NSD-NRC-97-5184
DCP/NRC0915
Docket No.: STN-52-003

SUBJECT: RESPONSE TO NRC COMMENTS AND PEER REVIEW COMMENTS ON THE
LOWER HEAD INTEGRITY UNDER IN-VESSEL STEAM EXPLOSION LOADS
REPORT

RESPONSES TO THE NRC QUESTIONS

fig 2

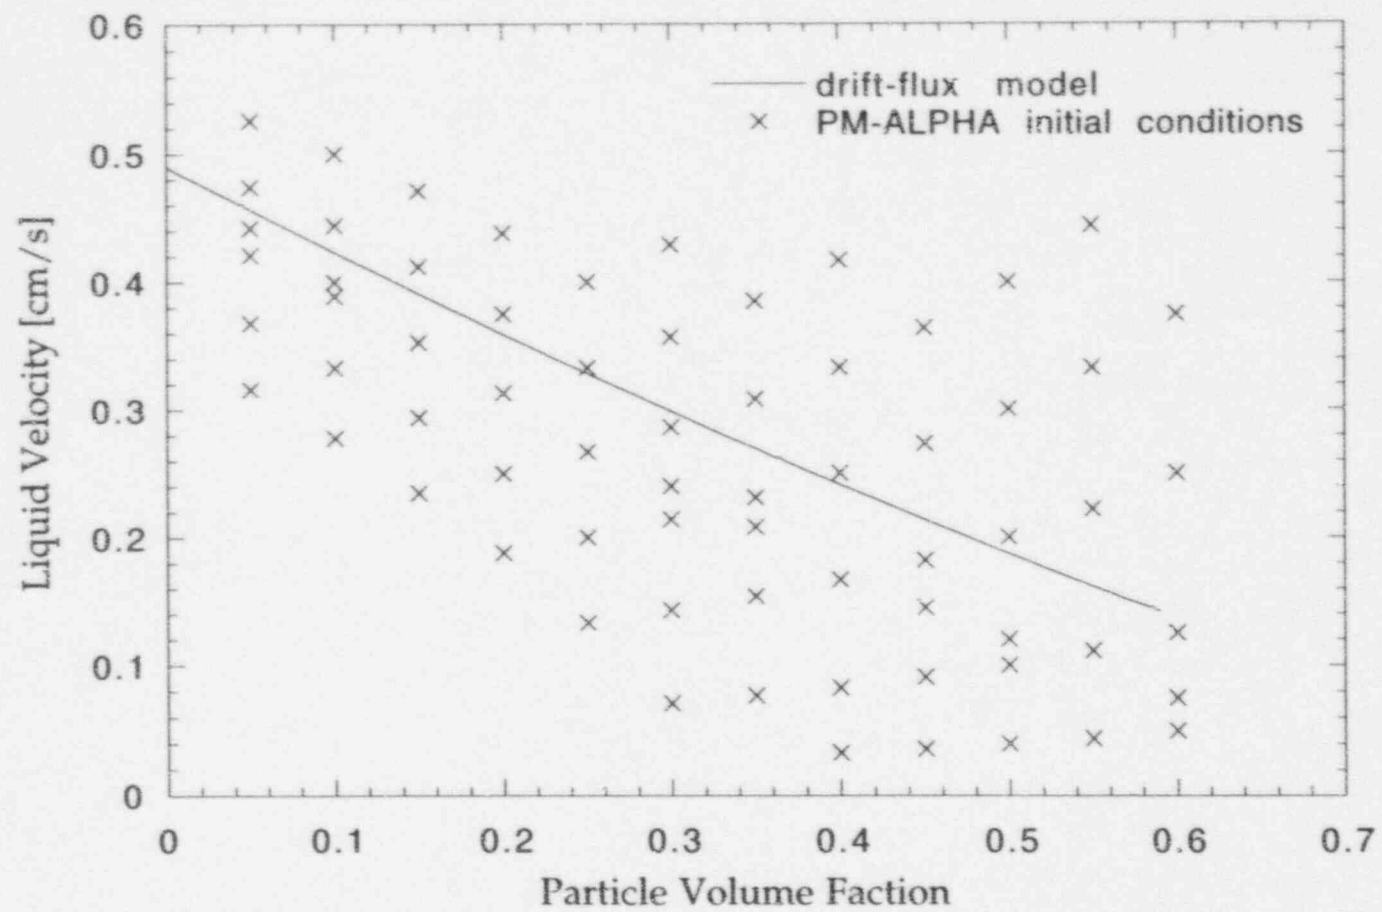
59. The FARO Experiments: Clearly the initial melt droplet size is very uncertain, as is the spread of the melt. L-14 appears to be the test in which the melt stream was best collimated, but one cannot tell whether the stream contracted as it poured through the gas space, or underwent a mild expansion (in L-11 the melt stream appeared to undergo a major expansion). If it is believed that the melt jet contracted (note typo: steam for stream 4 lines from end of page 3-25), then the radial meshing with $\Delta r = 5$ cm is too small. The choice of break-up

parameters appears arbitrary - presumably these were selected to give reasonable agreement with the experimental data. More detailed modelling of the melt release vessel indicates that the melt exit velocity was close to 3 m/s for most of the pour; this will not be replicated by the model shown in Figure 2. I am surprised that a Weber number criterion did not limit the droplet size; with the CHYMES implementation of this criterion we almost always get mean particles close to those observed in experiments (typically 3 - 5 mm). The comment on the absence of significantly superheated steam in the experimental data seems to me to be special pleading - it might be right, or the steam flow might be much less concentrated on axis than predicted by PM-ALPHA, giving steam closer to saturation conditions. It is difficult to relate the scales on the coloured contour plots in Figures 10 and 11 to the colour-scale, particularly because of interpolation effects. Is break-up still occurring after the particles have settled (unless they have solidified)?
